PLANNING COMMISSION AGENDA
Monday, July 25, 2022, at 6:00 p.m.
Caledonia Village Hall – 5043 Chester Lane

The Planning & Zoning Department and the Engineering Department have received a Preliminary Plat for The Glen At Waters Edge prepared by Grady L. Gosser R.L.S. of Trio Engineering, LLC, on behalf of Cornerstone Development of S.E. WI, LLC.

PROPOSED SITE PLAN
THE GLEN AT WATERS EDGE
Village of Caledonia, WI
(18.5 Acres)

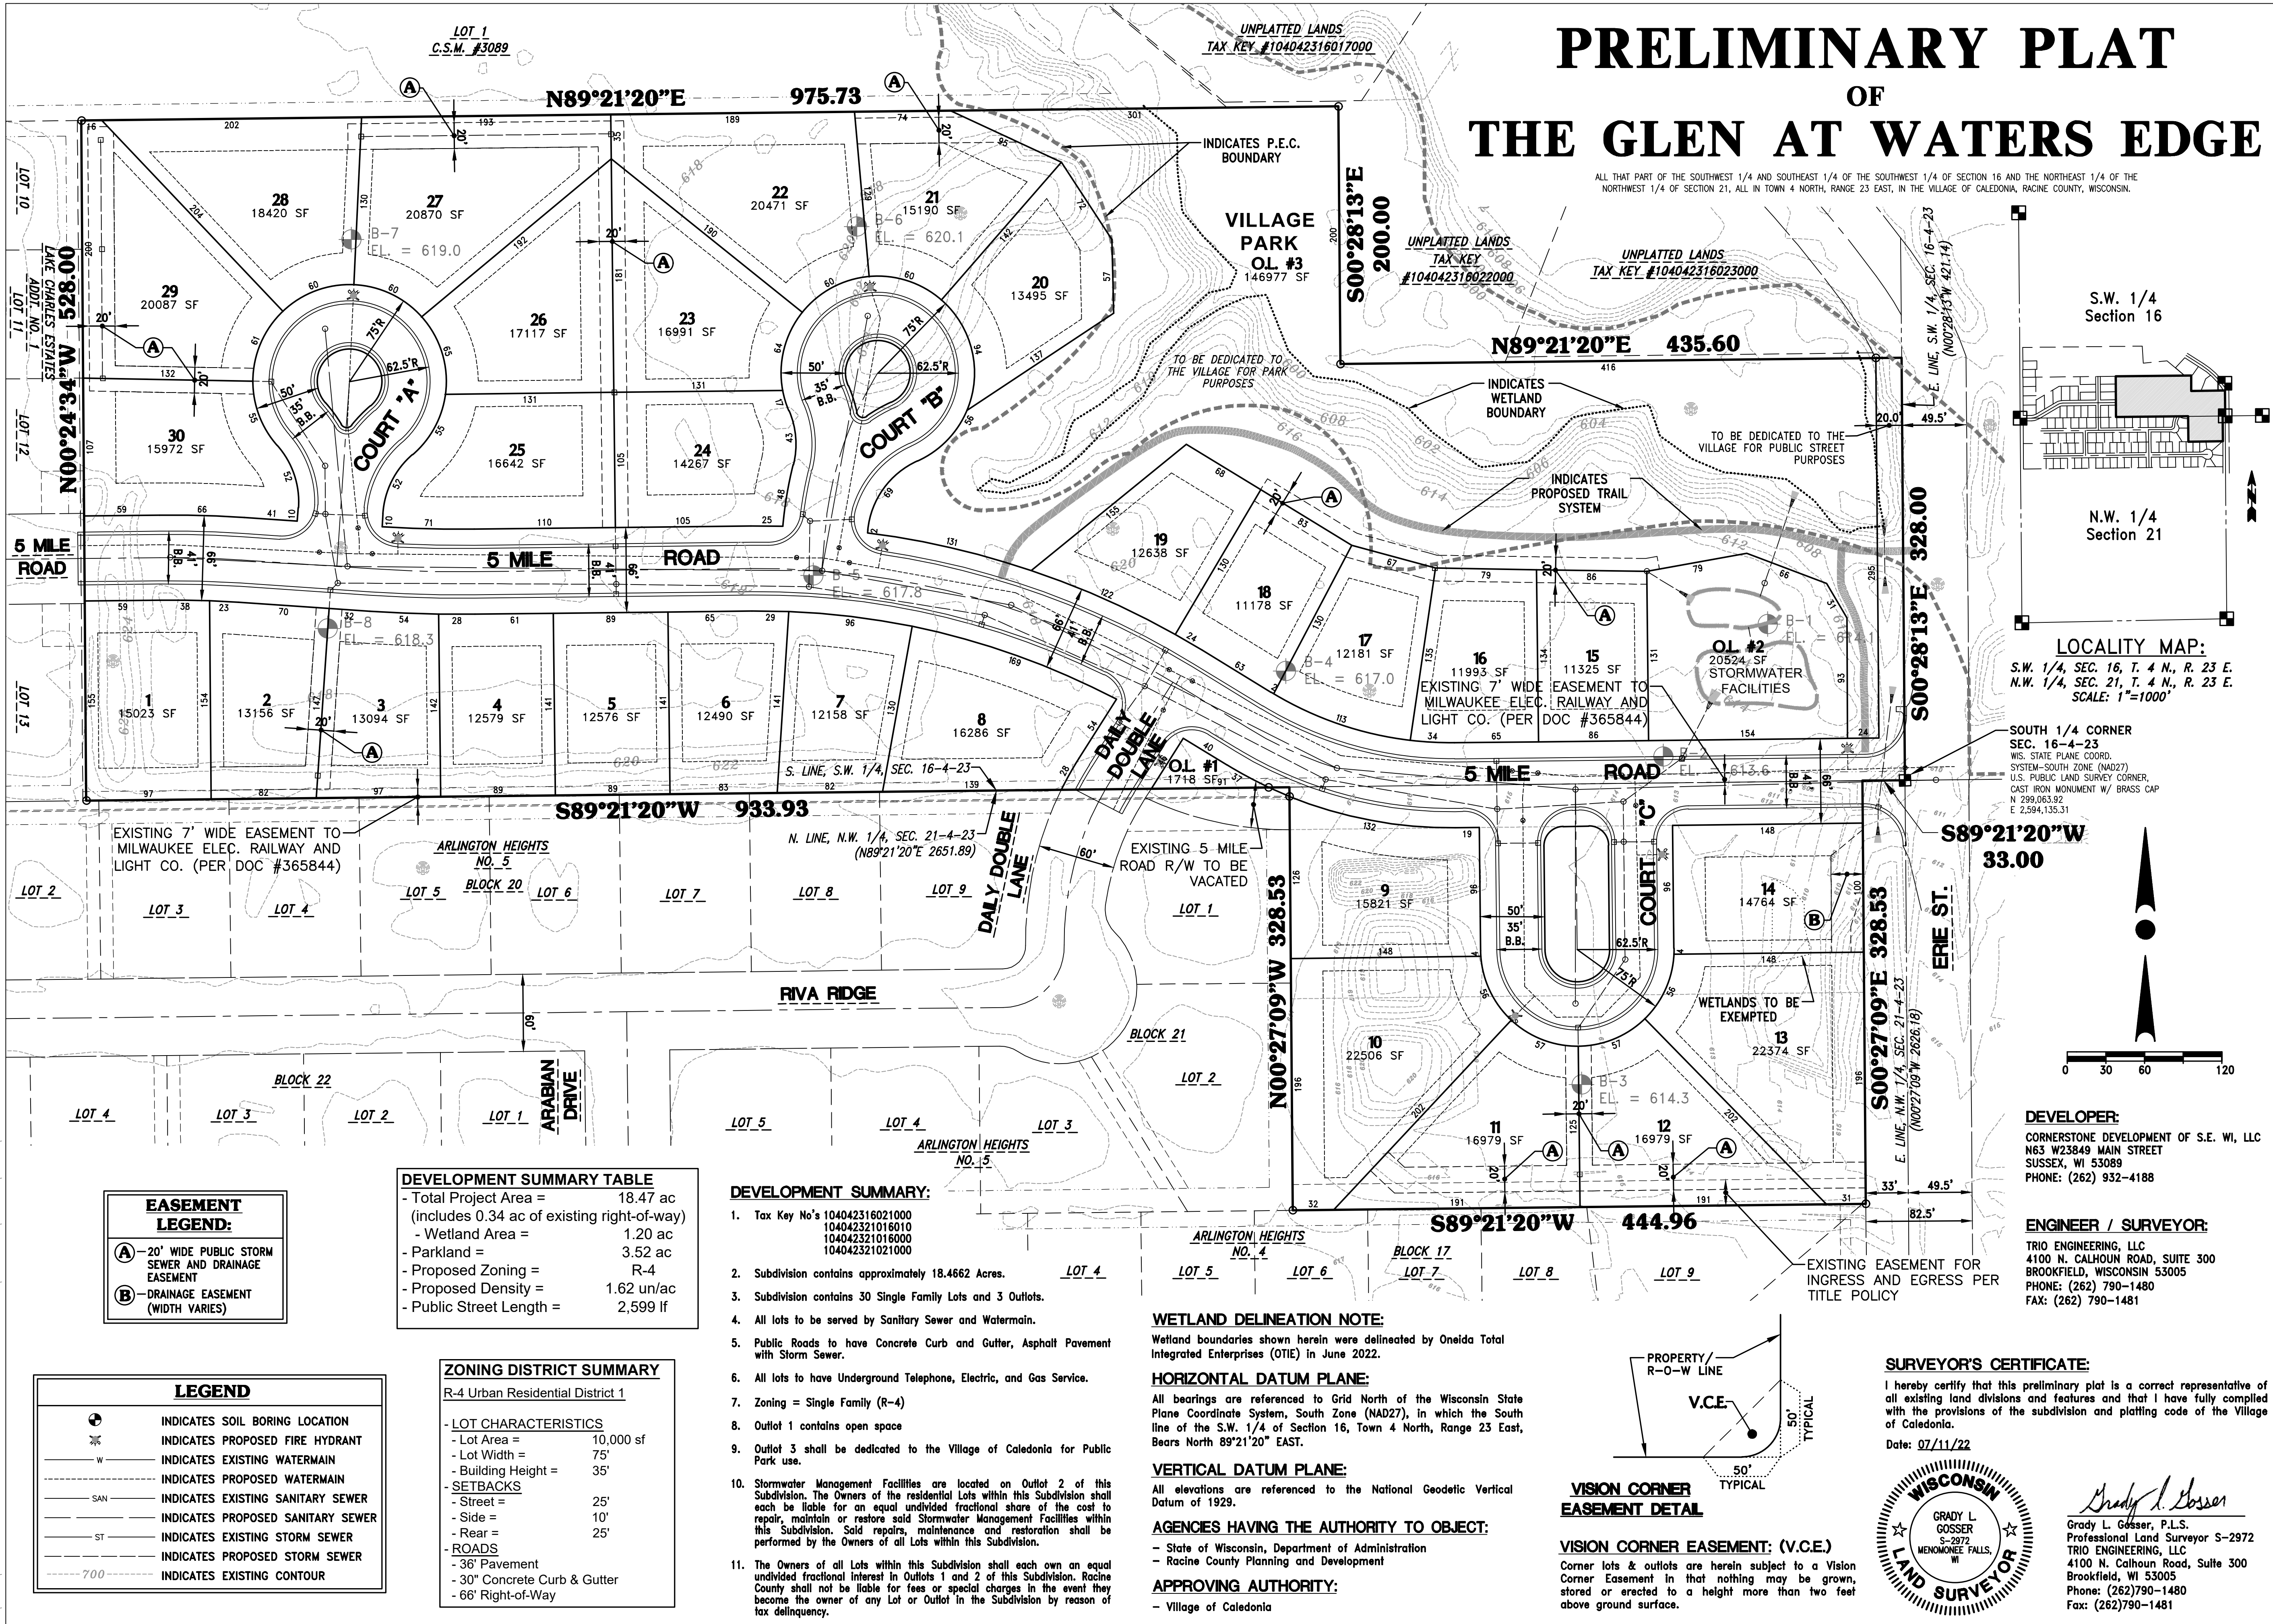
With the Preliminary Plat being located within the Sanitary Sewer and Water Service Areas the current Ordinance requires a minimum of 40% open space within the development. When performing calculations on the Preliminary Plat, it appears that the open space is approximately 26.66%. This will require a Modification Waiver from Ordinance 14-3-4(c)(4)(b)(ii). The Legislative and Licensing Committee had been working on a change in the Subdivision Ordinance that does not require open space for subdivisions within the Sewer Service Area that are served with both Sanitary Sewer and Water. They were also working on changing the Subdivision Ordinance so that Conservation Easements are not required within these subdivisions. This will also require a Modification Waiver from Ordinance 14-3-5(b). The Village Engineering Department supports the granting of the Modification Waivers as necessary.

The Preliminary Plat will need to be revised to update the Right of Way as indicated above.

In addition to No Access Restrictions there also will need to be 25' x 25' Vision Triangle Easements placed at the intersections of all corner lots (Lots 8, 9, 14, 24, 25, & 30). The detail provided will need to be adjusted as necessary and the easements will need to be shown on the lots.

The drainage of the lots within the Preliminary Plat according to the Master Drainage Plan, show 2 separate watersheds (M-14-2 & M-14-3). The Northern drainage basin predominately drains East to the Drainage Way located in Outlot 3, then to the road culvert under Waters Edge (M-14-2). The Southern drainage basin predominately drains East to Waters Edge then North to the same road culvert (M-14-3). A Storm Water Management Plan will need to be submitted, reviewed, and approved by the Caledonia Utility District. A preliminary Storm Water Management Plan has been submitted for review. This preliminary plan will be reviewed and comments provided to the Developer when completed. The Preliminary Plat has indicated that a Storm Water Management Pond will be installed in Outlot 2.

- The execution of a Pre-Development Agreement and Deposit of \$3,000.00.**
- Approval of Modification Waivers from Ordinance 14-3-4(c)(4)(b)(ii) and Ordinance 14-3-5(b).**
- Approval of the Rezoning Request from R-3 to R-4.**
- Correct the Road name from Erie Street to Waters Edge.**

- **Add Names for Cul De Sacs.**
- **Addition of the Owner of the Parcels. Include name, address, and telephone number.**
- **Addition of all platted Right of Ways within 300' of the Plat (Silent Sunday Court, North Pointe Drive & Waters Edge).**

- **Addition of all public and private easements within 300' of the Plat.**
- **Provide ownership information for lots within 100' of the Plat.**
- **Designate areas of slopes greater than 12%.**

- **Note if there are any Burial, Historical, or Cultural Resources on the property.**
- **A legal description of the parcels.**
- **Provide Density calculations for the Plat.**

- **Primary Environmental Corridor will need to be confirmed by SEWRPC.**
- **Wetland Buffers/Setbacks and uses are shown as necessary. Add Notes describing the maintenance (e.g., No Mow) of the Wetland Buffer. Also add Notes as necessary for what uses can be done in wetland buffers.**

- **Adjust Lot 17 to remove Primary Environmental Corridor from the Lot.**
- **The Right of Way width of 5 Mile Road shall be 70'.**
- **The Right of Way for the local streets shall be 66'. Radii for the cul de sacs shall be 80'.**
